RJC:24-209

**Re: State Significant Development SSD-42425537 (“the SSD”);
Alterations and additions to Waverley College including demolition works,
refurbished Centenary Building, library extension, construction of a new 6
storey building, new sports facilities and ancillary works (“the proposal”);
Waverley College, 131 Birrell Street, Waverley (“the development site”)**

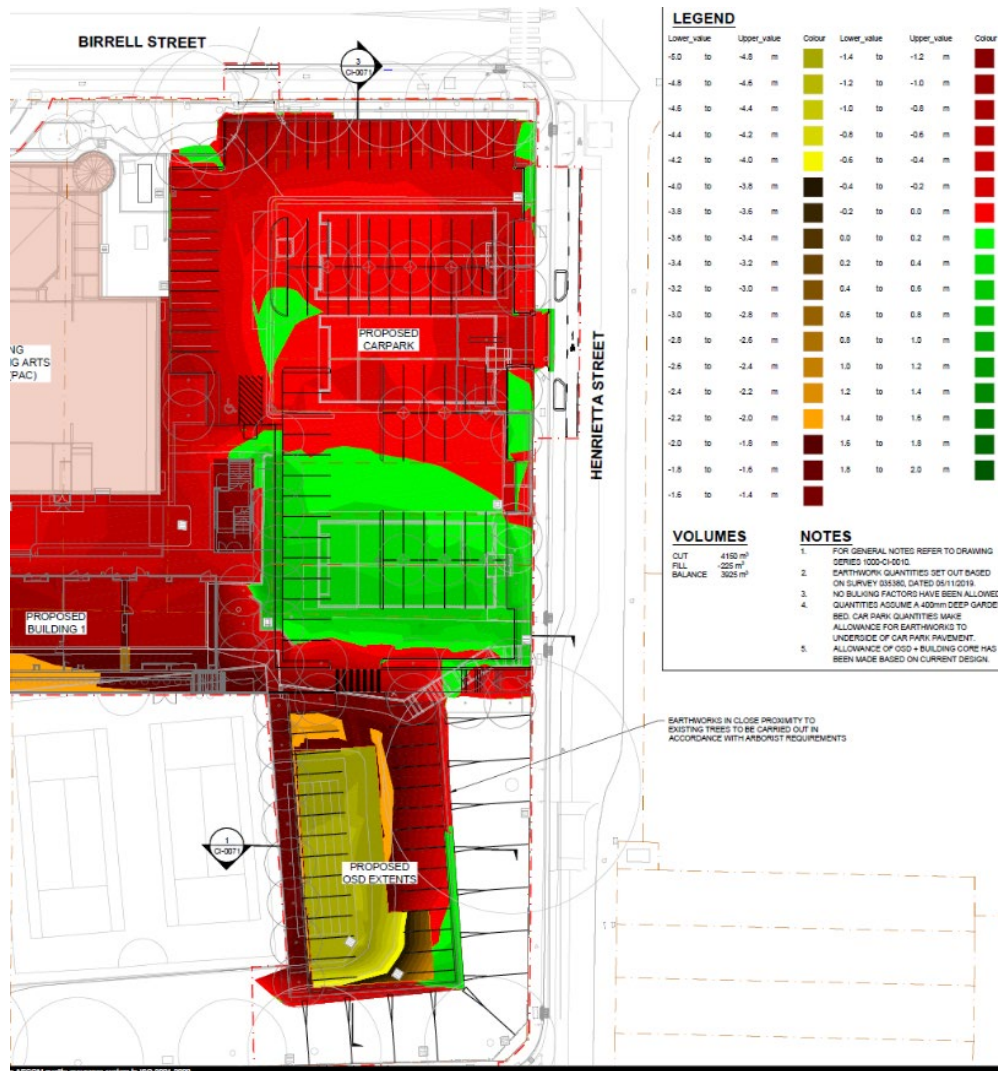
This reasonable concern is, however, compounded when reference is made to the Noise and Vibration Assessment Report in Appendix W of the EIS. It incorrectly identifies The Langlee as “Private Recreation – Waverley Bowling Club”. The Langlee is not identified as a “residential receiver” for the purposes of the assessment. In these circumstances, there is a reasonable basis for the Department to engage an independent acoustic consultant to undertake a noise and vibration assessment of the proposal.
